CLOVERLEAF SUBDIVISION

COVER SHEET

GEC PLANS

CLOVERLEAF SUBDIVISION		GRADING AND EROSION CONTROL PLANS	
SHEET	4	OF	11
JOB NO.		25158.01

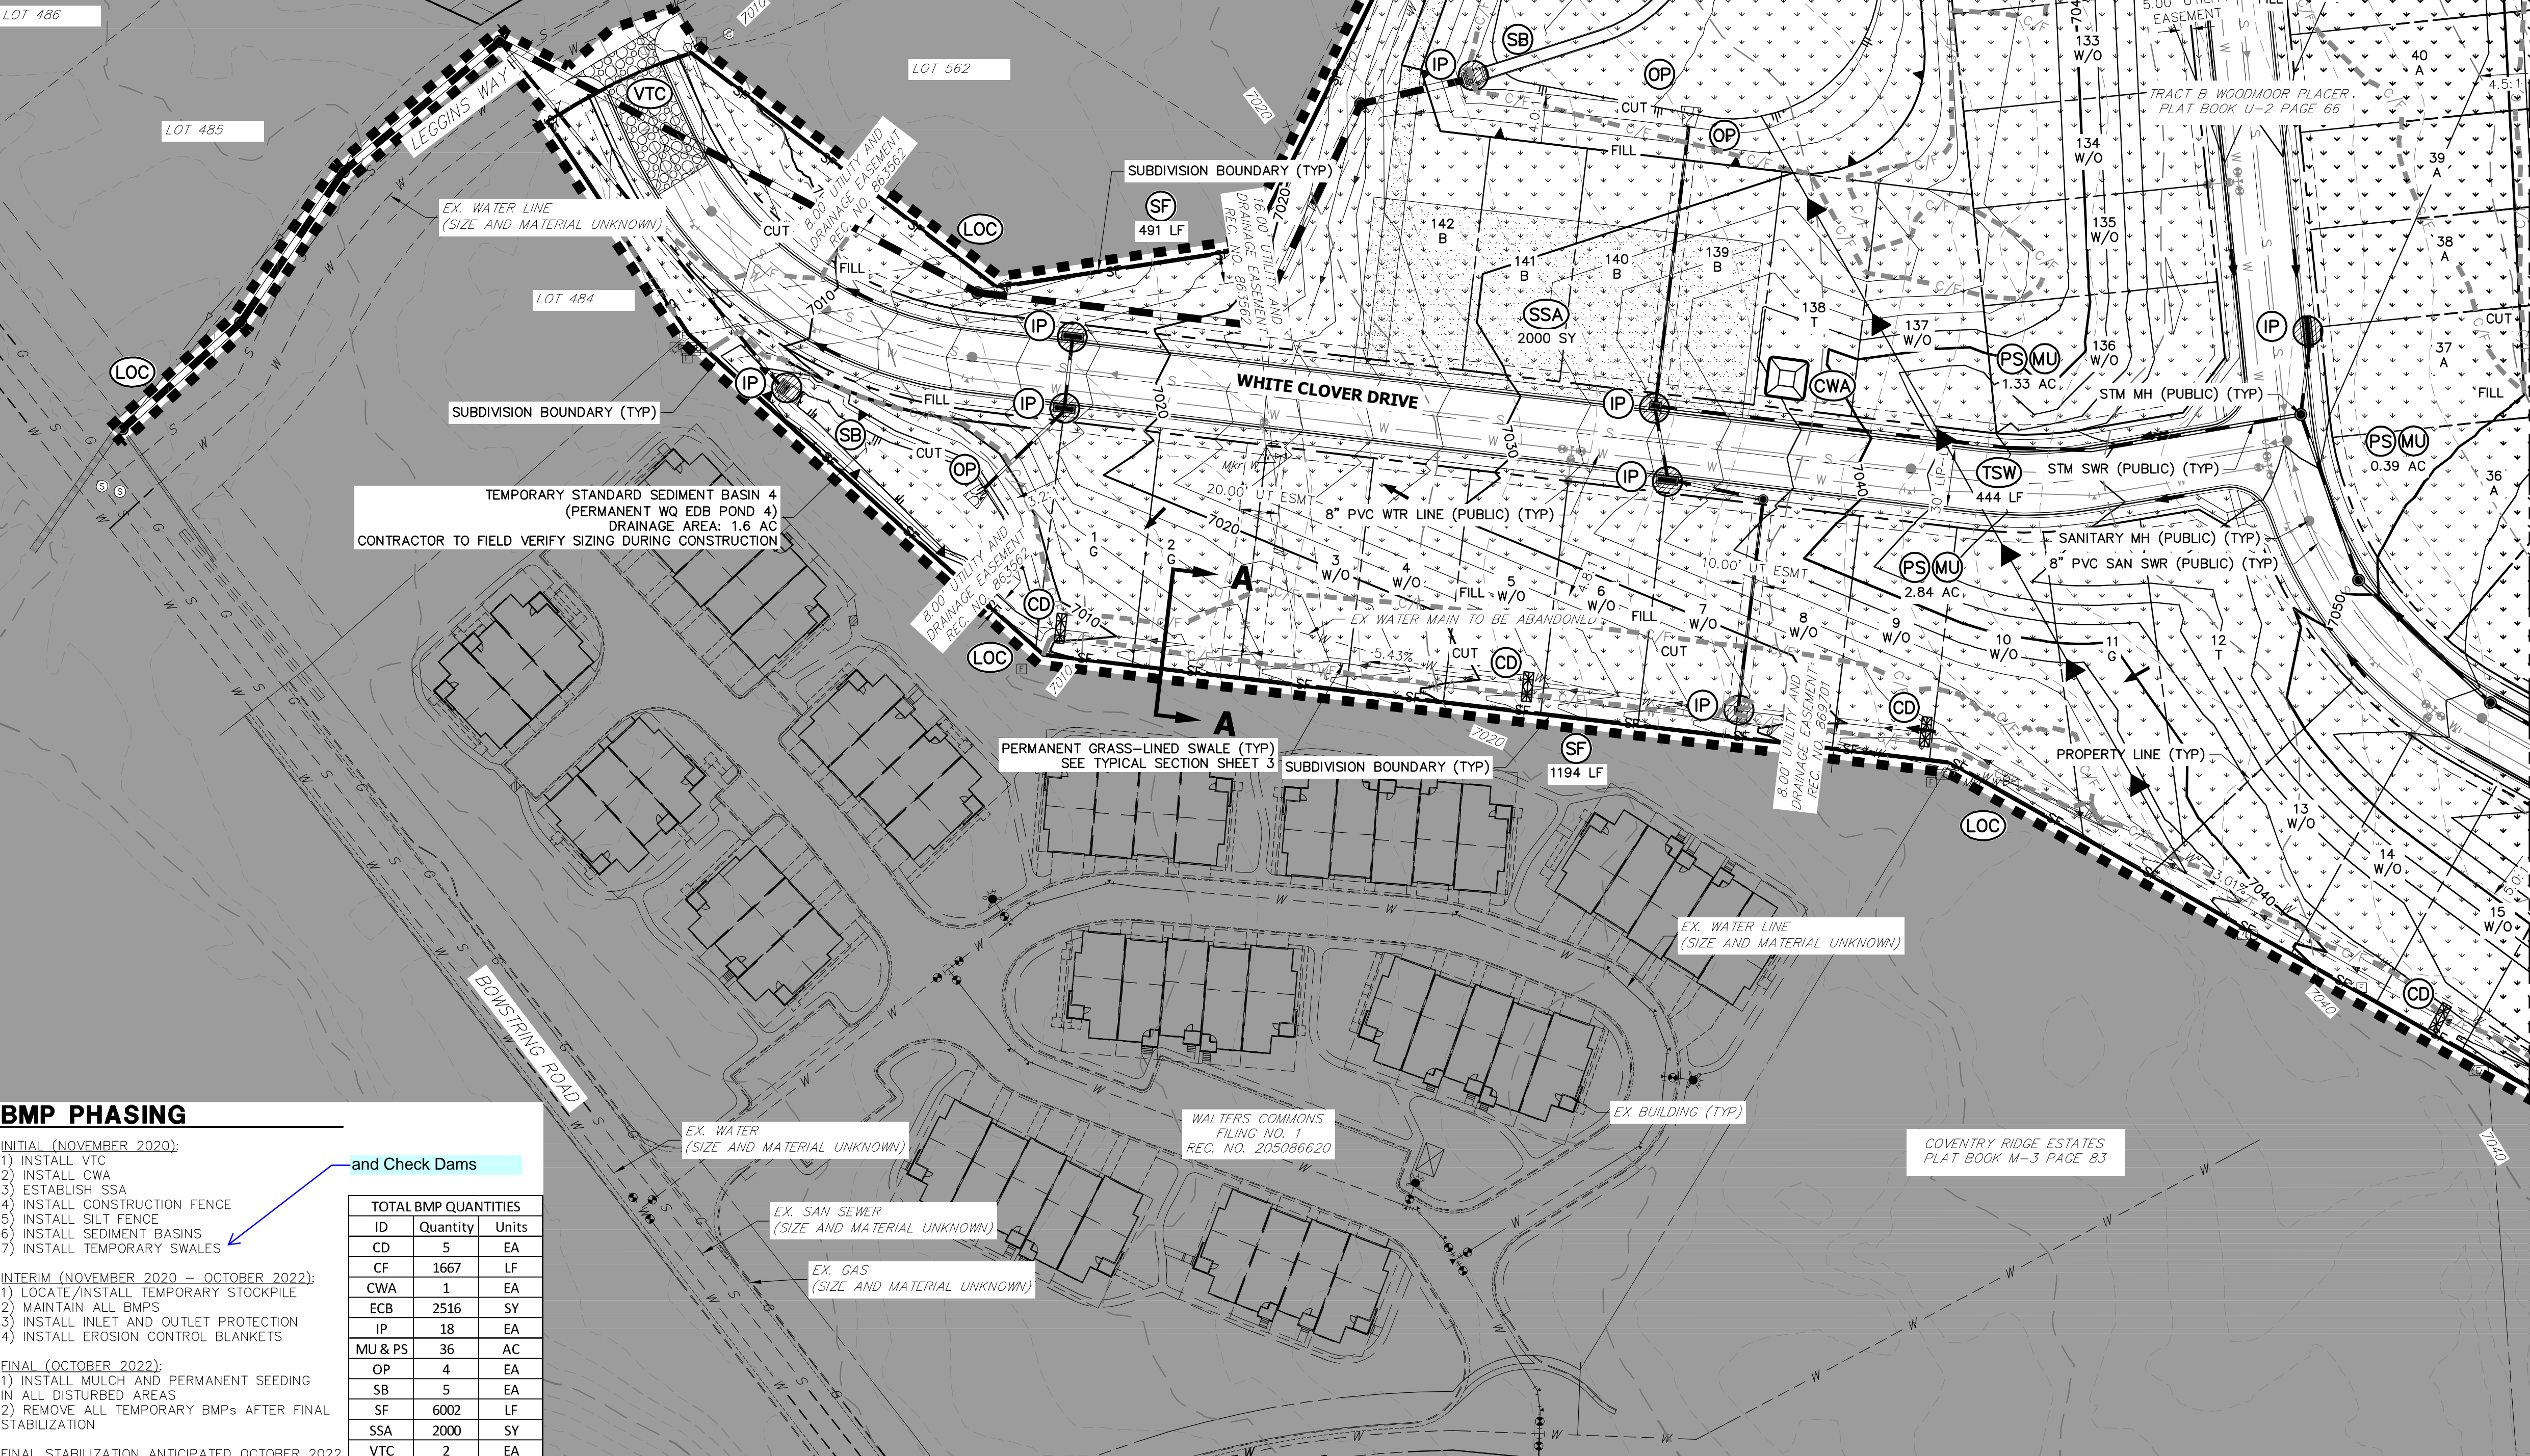
Add barricades and signage to block entrances
